Monthly Specification Update

Intel® Server Board S5520UR

Intel Order Number E69054-001

December 2010

Figure 1. Removing the Heatsink

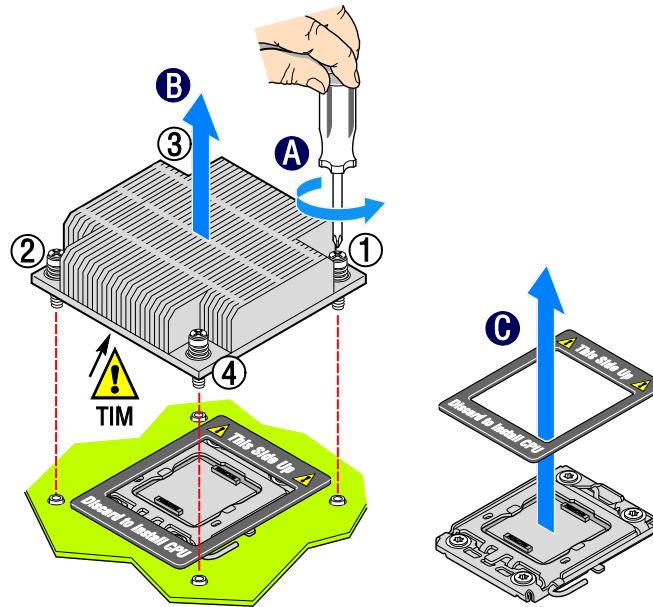
1. Proper Heatsink Installation and Removal Instructions are missing from Service Guide

- Problem:** The current documentation does not properly describe the installation and removal of the heatsink. Careful insertion and removal of the heatsink is required to prevent damage to the heatsink screws or backplate.
- Implication:** There is a possibility of damage to the heatsink if proper steps are not followed.
- Status:** Corrections incorporated into the latest version of the following Service Guides:
- Intel® Server System SR1600 Service Guide (Intel Order Number: E52880-003)
 - Intel® Server System SR1625 Service Guide (Intel Order Number: E52881-003)
 - Intel® Server System SR2600/SR2625 Service Guide (Intel Order Number: E51243-003)
- Workaround:** Perform the steps outlined below for installation and removal of the heatsink to avoid damage.

1. Loosen the four captive screws on the heatsink corners in a diagonal manner according to the numbers shown in figure 1 as follows:
 - Starting with the screw at location 1, loosen it by giving it **two rotations** in the anticlockwise direction and stop. (**IMPORTANT:** Do not fully loosen.)
 - Proceed to the screw at location 2 and loosen it by giving it two rotations and stop.
 - Loosen screws at locations 3 and 4 by giving each screw two rotations and then stop.
 - Repeat steps 1a through 1c by giving each screw two rotations each time until all screws are loosened.
2. Do one of the following:
 - If removing the heatsink for the first time, do the following:
 - i. Lift the heatsink from the board.
 - ii. Remove and discard the spacer (see letter “C” in figure 1).
